Request for Additional Information No. 363, Supplement 3

U. S. EPR Standard Design Certification

SRP Section: 06.02.02 - Containment Heat Removal Systems

Question 06.02.02-43:

Figure 06.02.02-43-1—Strainer Profile Depicting Modeled Portion

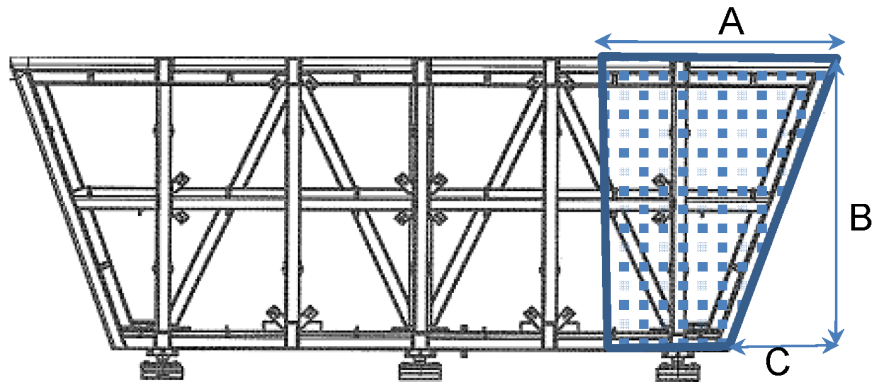
1. Describe the scaling methodology and explain how it ensures prototypical or bounding test data.
 - A. What similarities between test and plant conditions are preserved?

18. How is the tested strainers slope/angle for the nearly vertical face representative or conservative with respect to the plant design?
19. Describe how the selected test termination criteria are realistic or conservative.

Items in the U.S. EPR test apparatus that require scaling are the strainer, RB, flow, and design basis debris source term. The U.S. EPR strainer is shaped like an upside down trapezoidal prism (see Figure 06.02.02-43-1). Modeling one side (see 06.02.02-43, Face B) and a portion of the top (see Figure 06.02.02-43-1, Side A) of the strainer conservatively allows the test strainer to be aligned perpendicular to the flow, which maximizes the ability for debris to form a bed on the strainer. The slope angle of the slanted face of the test facility strainer is identical to the strainer designed for plant operation. A 0.75 foot portion on the bottom of the strainer is comprised of a skirt and support feet. This bottom portion has

The strainer width (not depicted in Figure 06.02.02-43-1) is determined by the physical size of the onsite test facility flume (5 feet width). The screened area of the modeled strainer in the test facility was determined by calculating the surface area using the test strainer's slanted screen height (7.5 feet), length (6.62 feet), and width (5 feet). Dividing the test flume strainer surface by the actual minimum strainer surface area for the U.S. EPR design yields a scale factor of 9.37 percent. Scaling the strainer as a single face perpendicular to the flow is conservative to the plant design and will provide a maximum head loss with respect to the U.S. EPR strainer.

18. The slope angle of the strainer's vertical face in the U.S. EPR design is approximately 20°. The test loop's screened vertical face measures to approximately 88.1 inches, and the overhang of the strainer in the test flume is approximately 30.5 inches. The slope of the vertical face in the test apparatus is approximately 20°. Because the test loop utilizes one-to-one vertical scaling of the U.S. EPR design, using the identical slope for the vertical face of the strainer is prototypical.
